BEFORE THE  
FEDERAL ENERGY REGULATORY COMMISSION  
APPLICATION FOR LICENSE FOR MAJOR PROJECT  
**SUSITNA HYDROELECTRIC PROJECT**

SUSITNA HYDROELECTRIC PROJECT  
VOLUME 10B  
EXHIBIT E      CHAPTER 11  
APPENDICES I THROUGH J  
AGENCY CONSULTATION

CORRESPONDENCE RELATING TO DRAFT LICENSE REVIEW

APPENDIX 11.I  
DRAFT LICENSE REVIEW

Attachment: Map Showing Conflicts

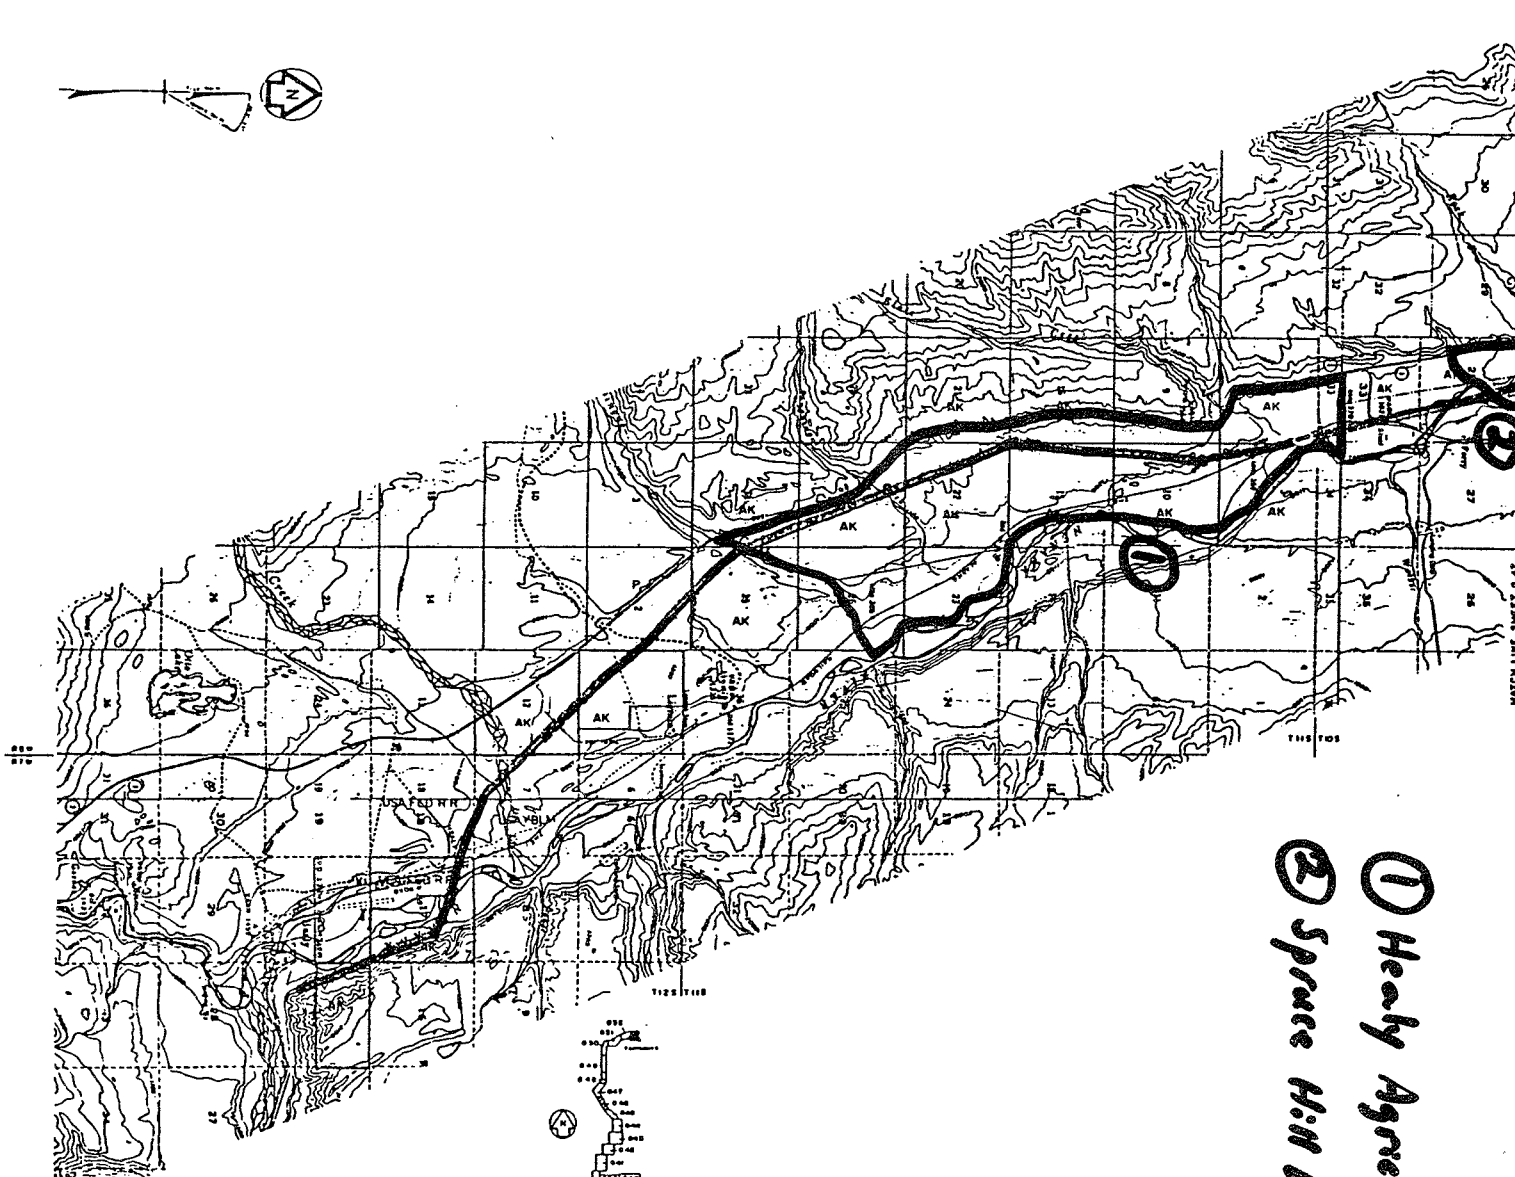
The overall District concern is the impacts the proposed right-of-way will have on land disposal actions and proper land management practices. Particularly, we would like to know why the new transmission line couldn't be placed adjacent to the existing transmission lines to lessen impacts? I am sure other questions and concerns will become evident as the project becomes more finalized. We look forward to working with you on the resolution of these conflicts. Please keep us informed on the progress of your studies in these matters.
